The authors would like to thank Anonymous Referee #1 for their comments on our manuscript entitled, "Expanding the coverage of MISR aerosol retrievals over shallow, turbid, and eutrophic waters." Below, we have addressed their comments and made the necessary changes in the manuscript.

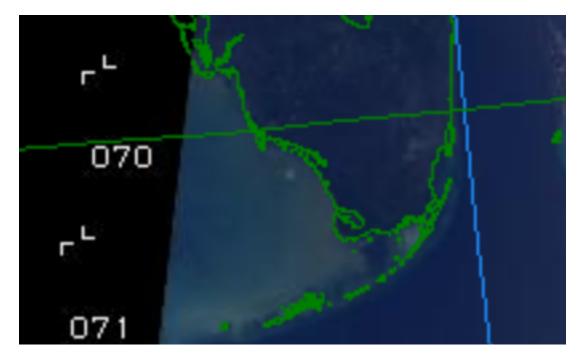
"In Fig. 5d, the transition from AOD retrieved by DW to SW is not very smooth at around 82.5W, 25N; DW AOD over deep water is larger than SW AOD over shallow. At 81.5, 25.7N, there are some hotspots. All these should be discussed."

The transition from AOD retrieved by DW to SW around 25° N, 82.5° W is discussed on L260:

"However, a small gradient in AOD is seen along the far western edge of the swath around 25° N, where the water is deeper than 50 m and more than 5 km from land. In Fig. 5b this location is

designated as deep water. Here the AODs from the DW algorithm are reported instead of those from the SW algorithm. Our testing suggests that these AOD gradients, if present, are generally small and have a minimal impact on the overall accuracy of the MISR aerosol retrievals."

The AOD hotspot at 25.7° N, 81.5° W in Fig. 5d is likely real. It is in both the DW and SW AOD plots and the MISR DF camera has enhanced radiance in that area, suggesting a real aerosol feature:

Additionally, if you <u>toggle between MODIS Terra and Aqua visible imagery</u>, it appears there may be white smoke just to the NE of the MISR AOD hotspot, around 25.91° N, 81.52° W.
